DEVELOPMENT REVIEW BOARD
SUPPLEMENTAL SUBMITTAL

PROJECT NO. PR-2021-006070

Re: Westpointe40 North Site Plan DRB Comment Responses (PR-2021-006070)

This memo outlines the responses and changes made to the site plan for the proposed 150K spec industrial building at Westpointe40 based on the comments received and reviewed at the December 1, 2021 DRB meeting. The comments are numbered and followed by the response in italics.

DRAWING SHEET
L101

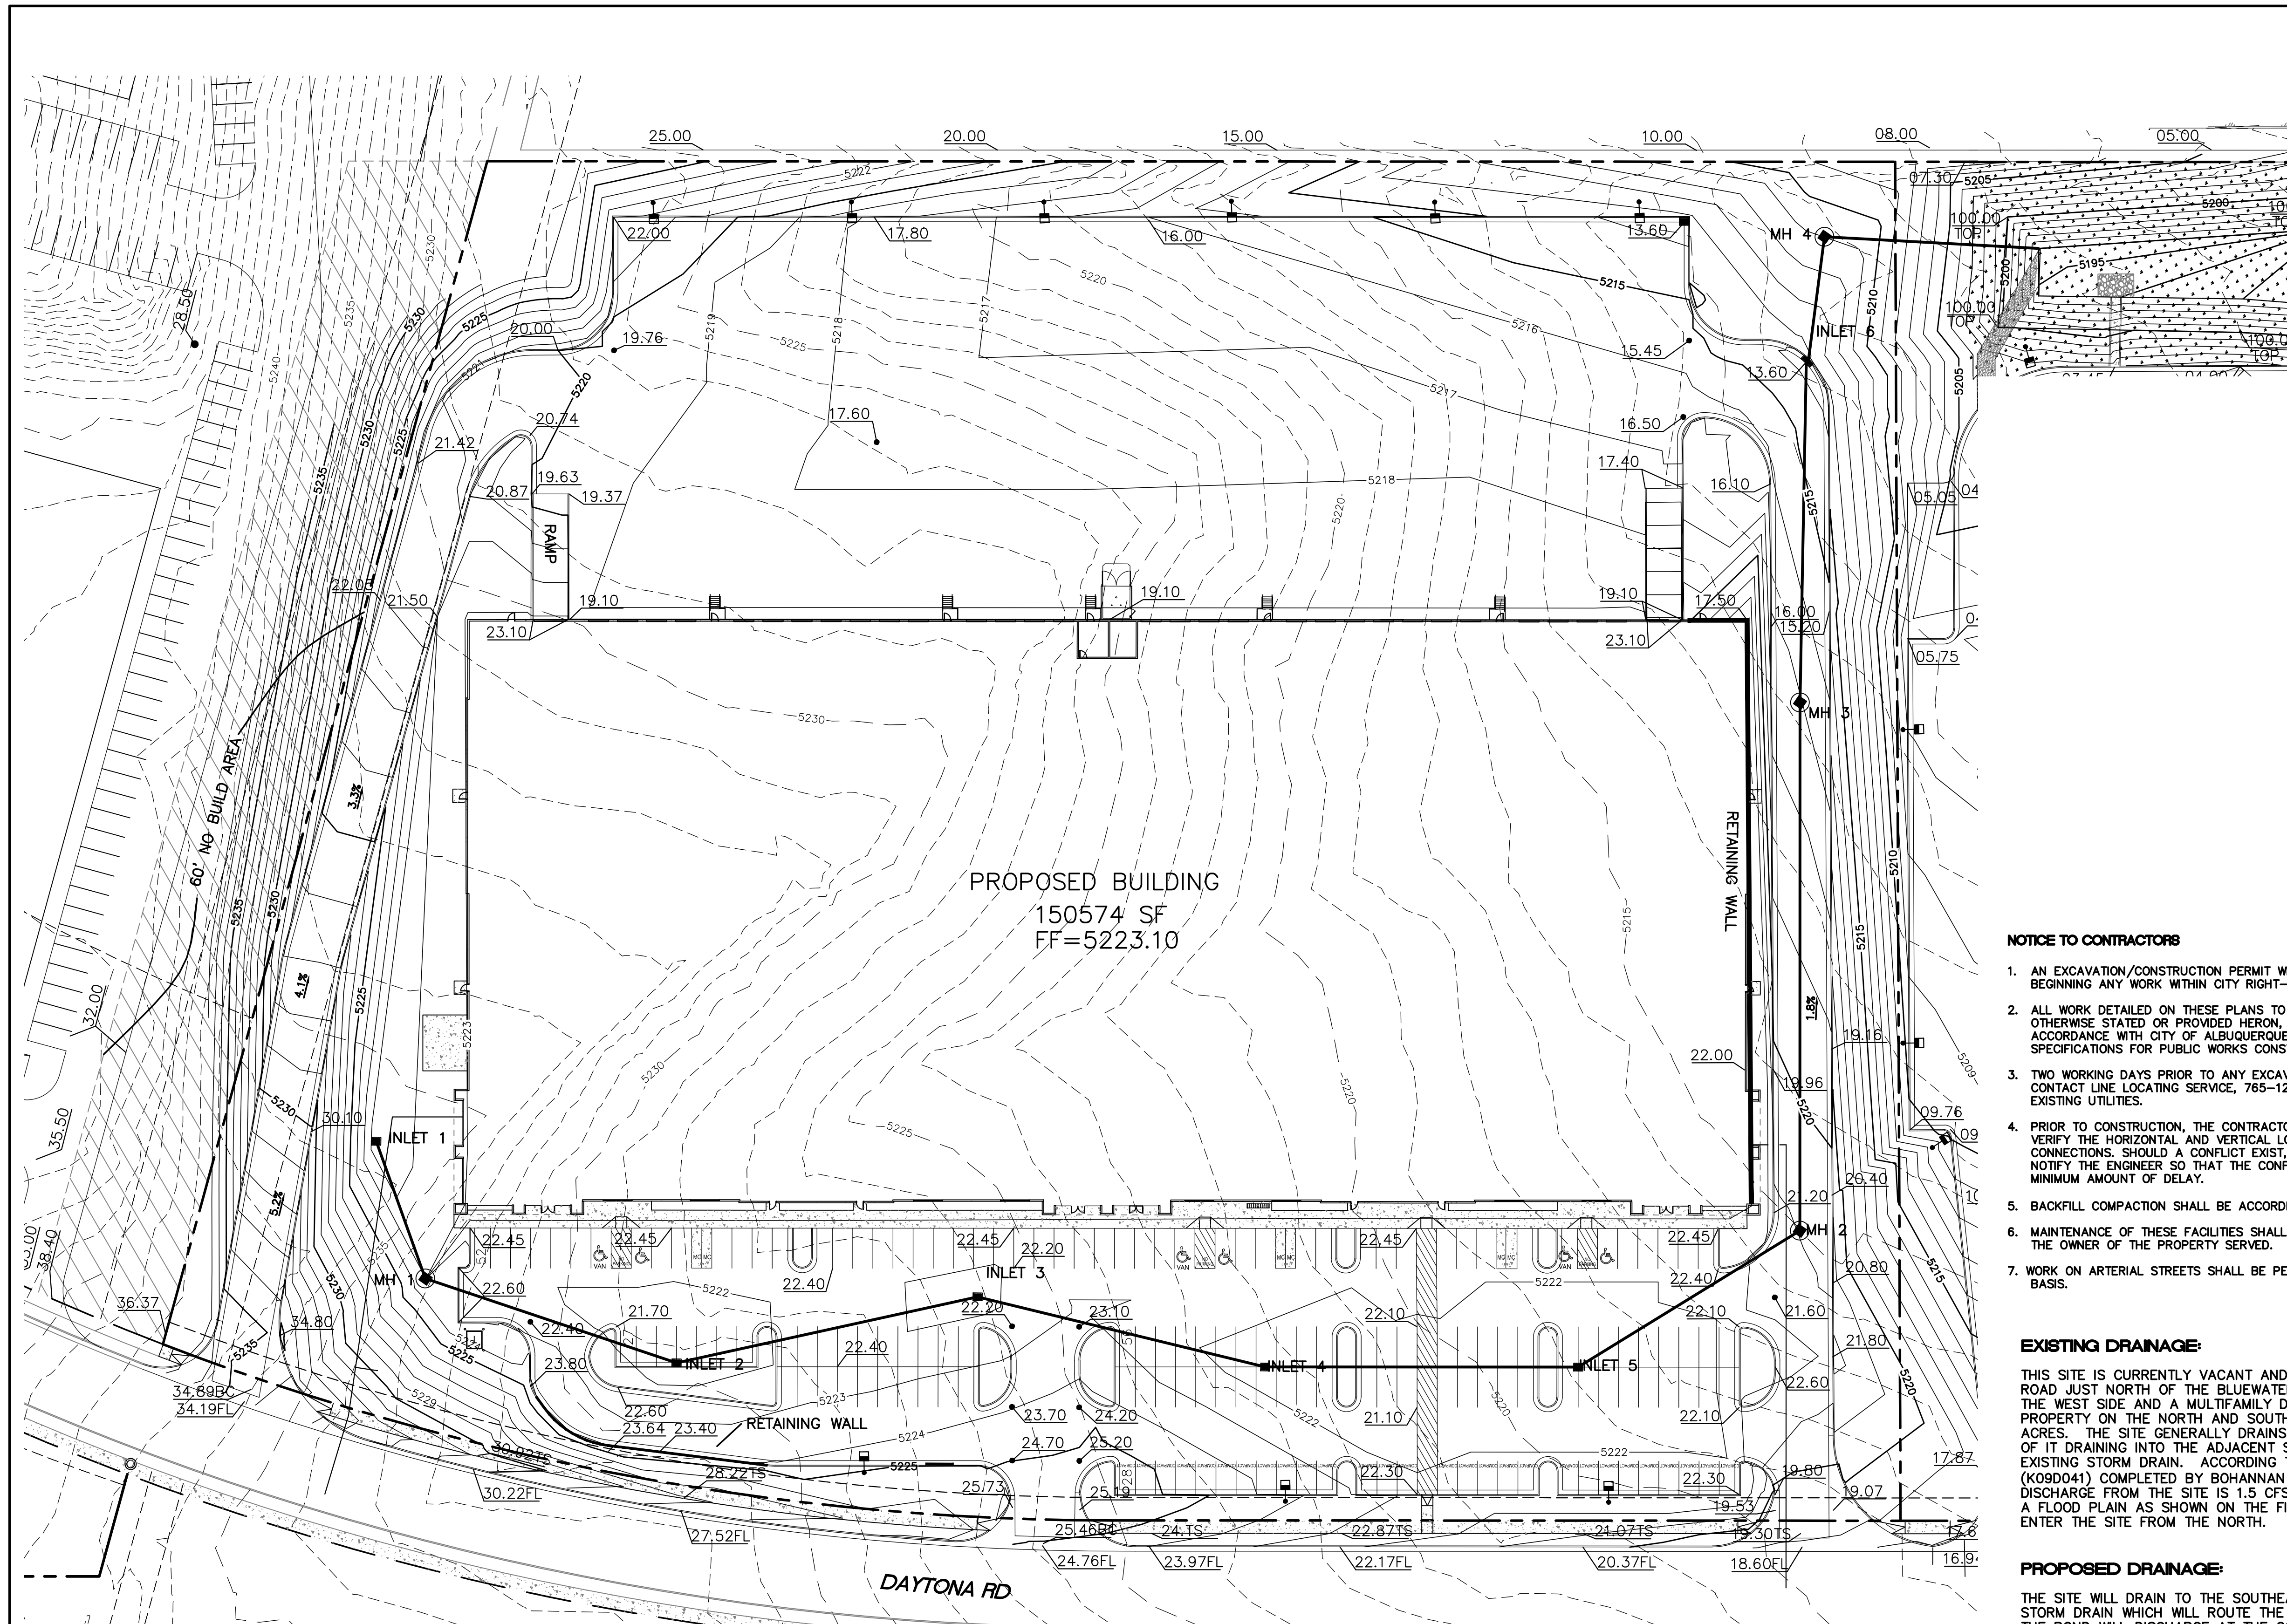
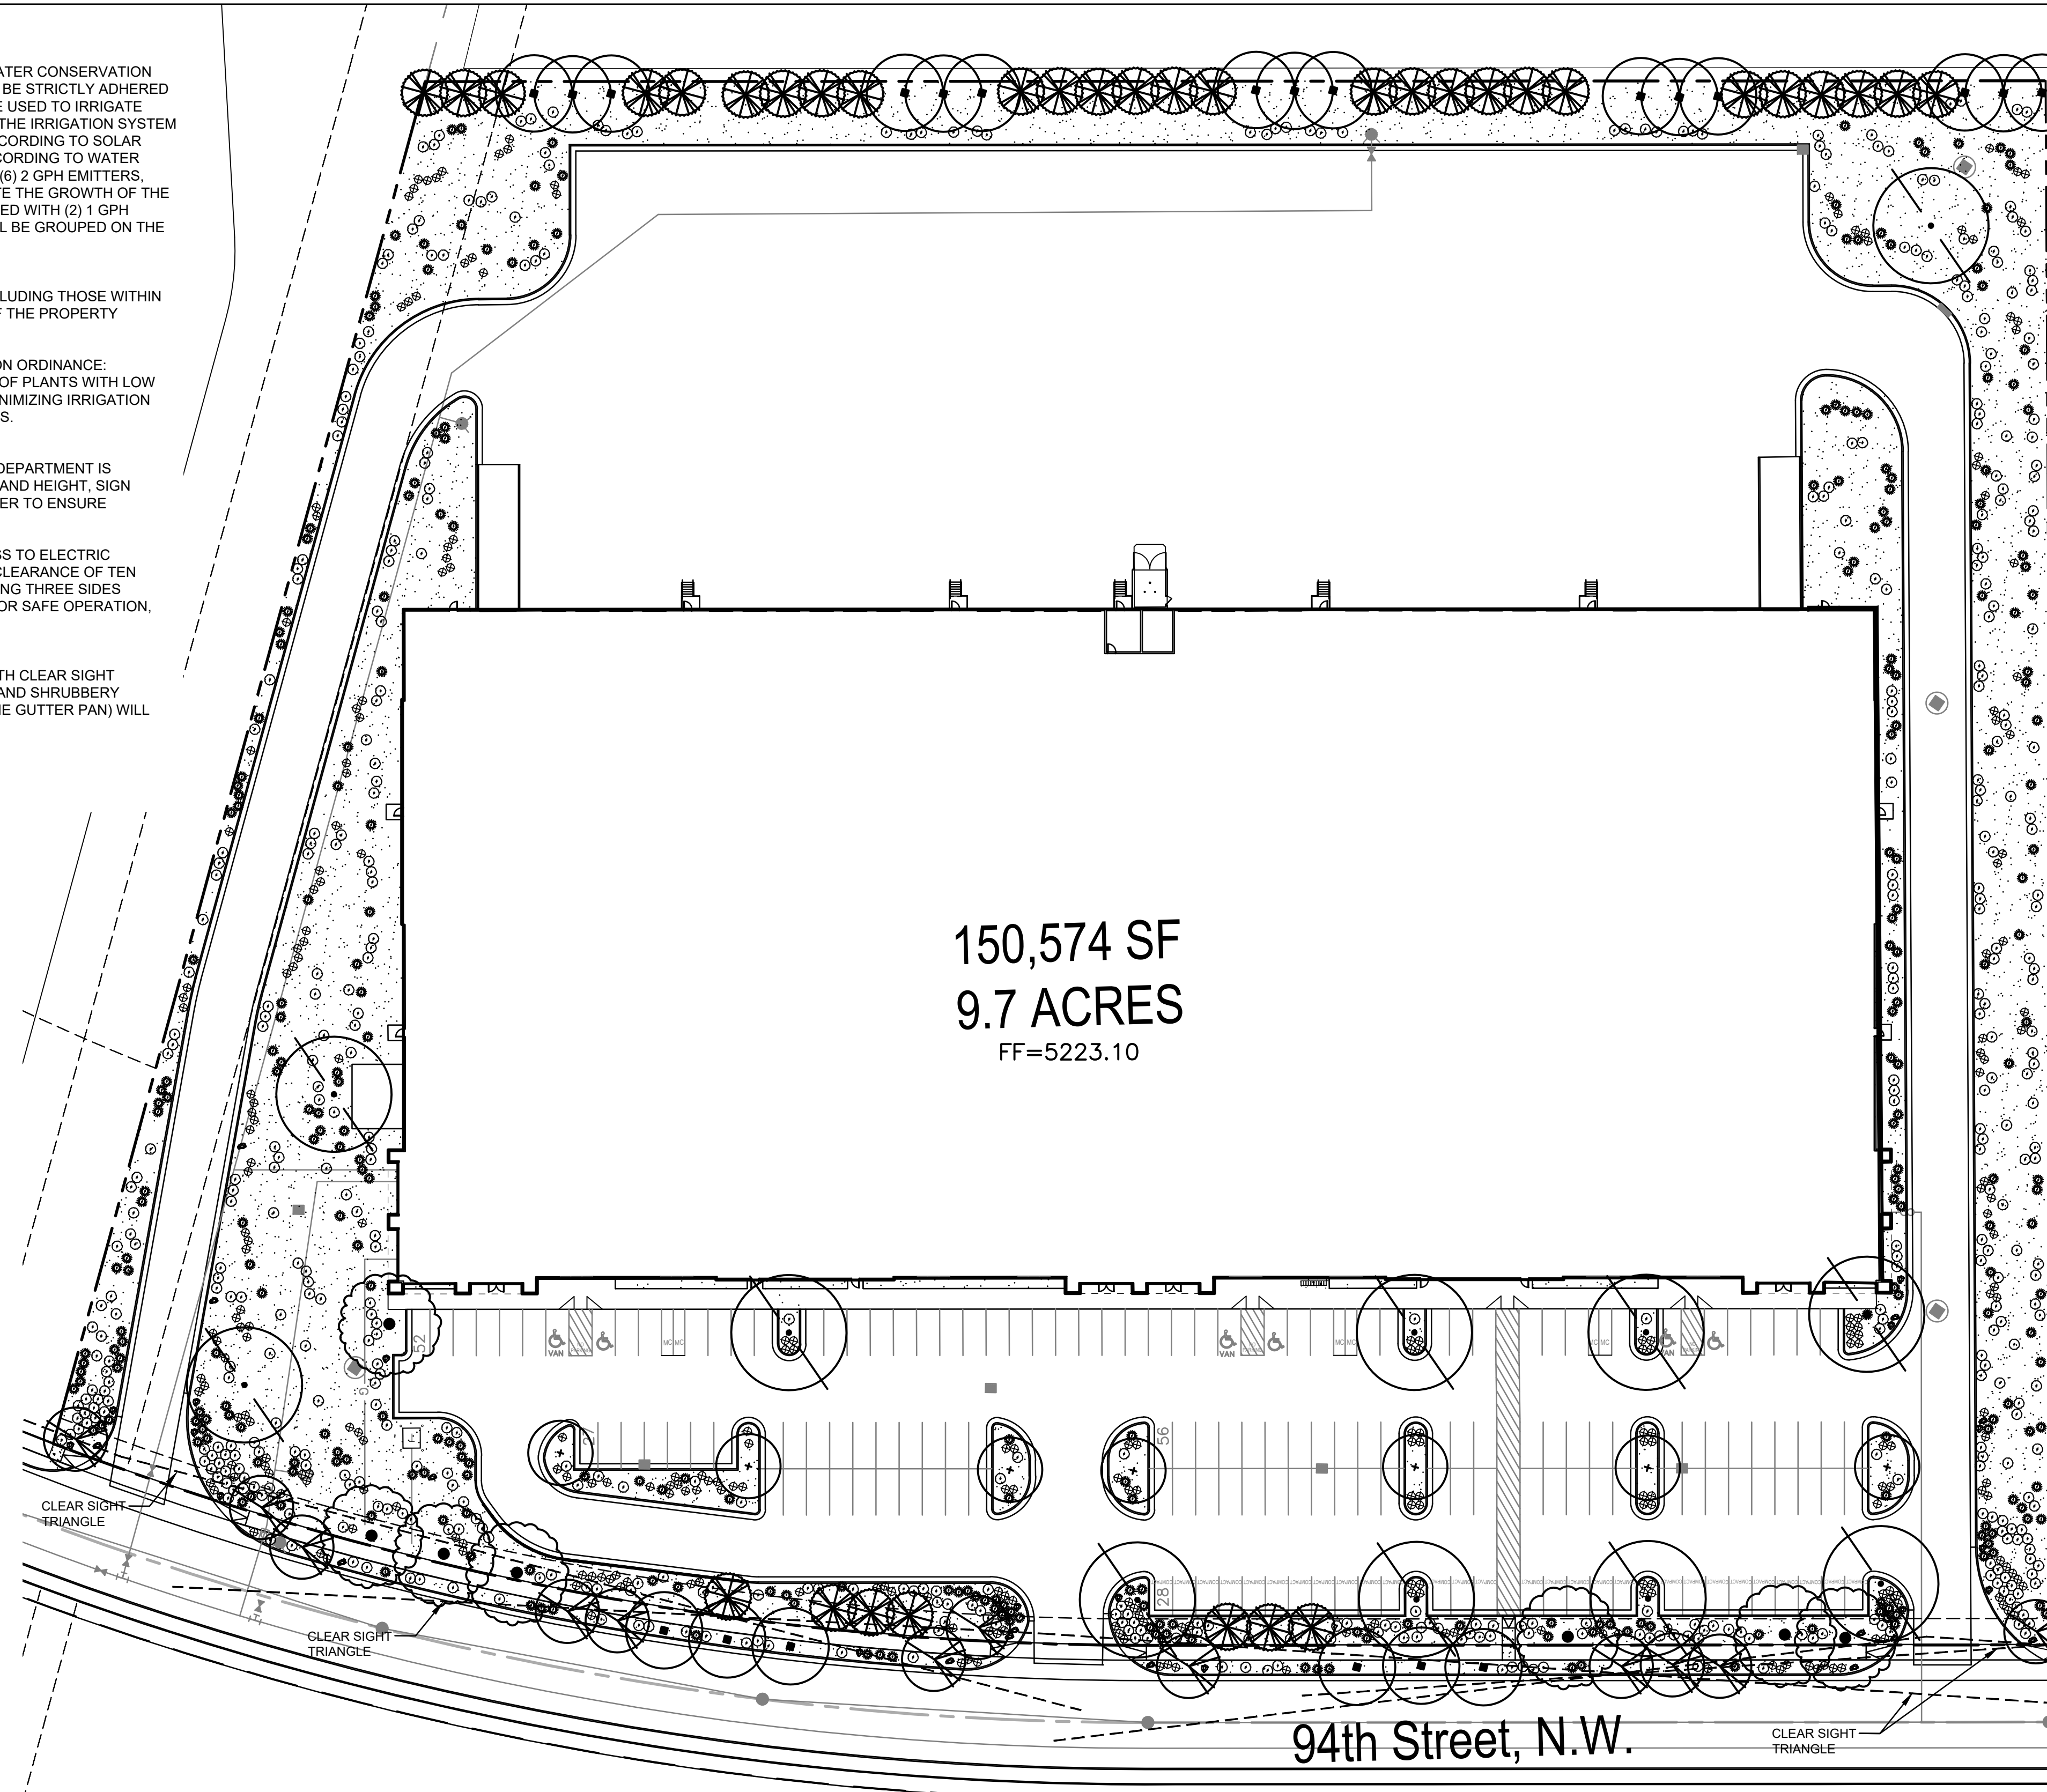
4. With the clear sight triangles shown on the landscape plan, will height restrictions be met? It is not clear.
 - *The landscape plan is showing street trees that are required along Daytona Road to comply with the IDO and Street Tree Ordinance. Within the clear sight triangle, these trees will need to be maintained and will be pruned to meet the minimum clearances.*
